Proposals for Consistency: Parameter Names & Figures

John D'Ambrosia, Force10 Networks

Introduction

- Reference Comment # 327 (D'Ambrosia) against D2.1
- Pile on Comment # 15 (Anslow) against D2.2:

Figure 85-4—Maximum insertion loss TP0 to TP2 or TP3 to TP5

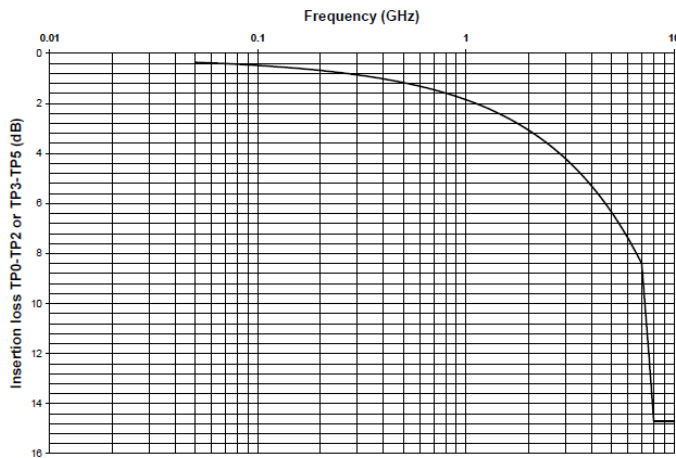
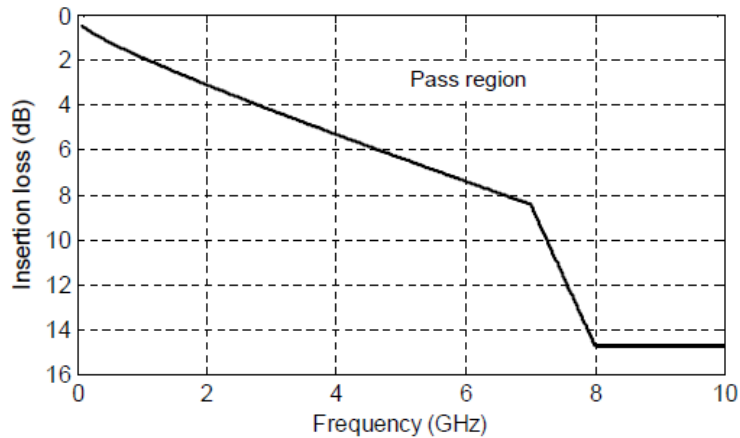
Graphs are also inconsistent

- Use both linear and log frequency scales as appropriate
 - Change 85A-4 and 85A-12 to linear
- Change all graphs:
 - Gridlines to be dashed and major only for linear axes
 - X axis labels at bottom
 - Axis labels use at least 8 pt font
 - Frequency values use GHz
- Indicate compliant region (work on terminology)
